Bulletin No.: 10-06-01-008M

Subject: Engine Oil Consumption on Aluminum Block/Iron Block Engines with Active Fuel Management (AFM) (Install AFM Oil Deflector and Clean Carbon from Cylinder and/or Install Updated Valve Cover)

Models: 2007-2014 Cadillac Escalade Models
2007-2013 Chevrolet Avalanche, Silverado
2007-2014 Chevrolet Suburban, Tahoe
2010-2012 Chevrolet Colorado
2010-2015 Chevrolet Camaro
2007-2013 GMC Sierra, Sierra Denali
2007-2014 GMC Yukon Models
2010-2012 GMC Canyon
2008-2009 Pontiac G8 GT
Vehicles Built Prior to February 1, 2011 Require Updated Valve Cover and October 2010 Require AFM Shield
Equipped with Any of the Following Engines:
– Aluminum Block V8 Engine with Active Fuel Management (AFM) (RPOs LH9, L94, LZ1, L99, LC9, LH6, L76, L92, LFA (Hybrid))
– Iron Block V8 Engine with Active Fuel Management (AFM) (RPOs LMG, LY5)

2740641

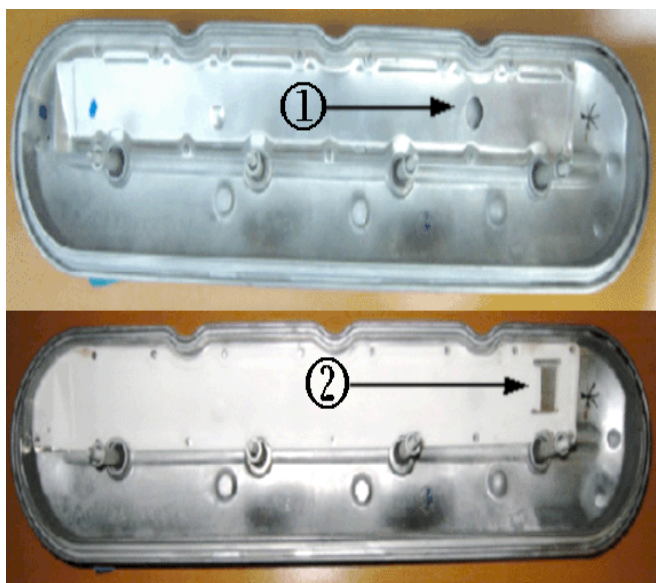
Aluminum or Cast Iron Block - Oil in Intake Manifold - Install Updated Valve Cover on All Models Built Prior to February 1, 2011

PCV pullover or an overactive lifter can cause oil to be pulled through the PCV system even at low vehicle mileage. A correctly functioning PCV system will only leave a film of oil in the intake manifold. Inspect the intake manifold to see if there is any oil puddling in the bottom. If there is you will need to replace the left valve cover. Two new left rocker arm covers have been released for trucks and vans. Technicians should replace the left rocker arm cover with GM P/N 12570427 for 2007-2008 or GM P/N 12642655 for 2009-2011. Refer to the Parts Information below for the Camaro. This rocker arm cover has a relocated PCV drain hole that prevents oil from entering the intake manifold. Refer to Valve Rocker Arm Cover Replacement - Left Side in SI.

- 1) Old Design
- 2) New Design

Note: These rocker covers are for specific years. The PCV orifice is different for each. The correct cover must be used or an SES light may set.

2474205

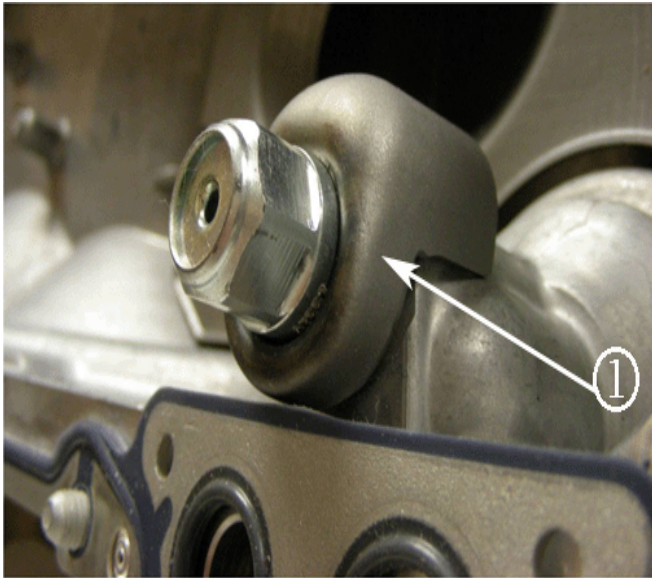
4. Remove the AFM valve (1).

2474207

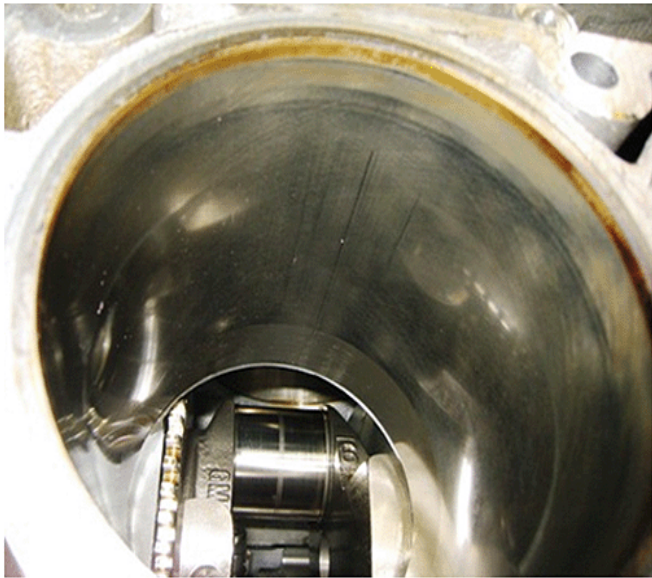
5. Install the new shield (1), GM P/N 12639759, and tighten the AFM valve to the oil pan to 28 N•m (20 lb ft).
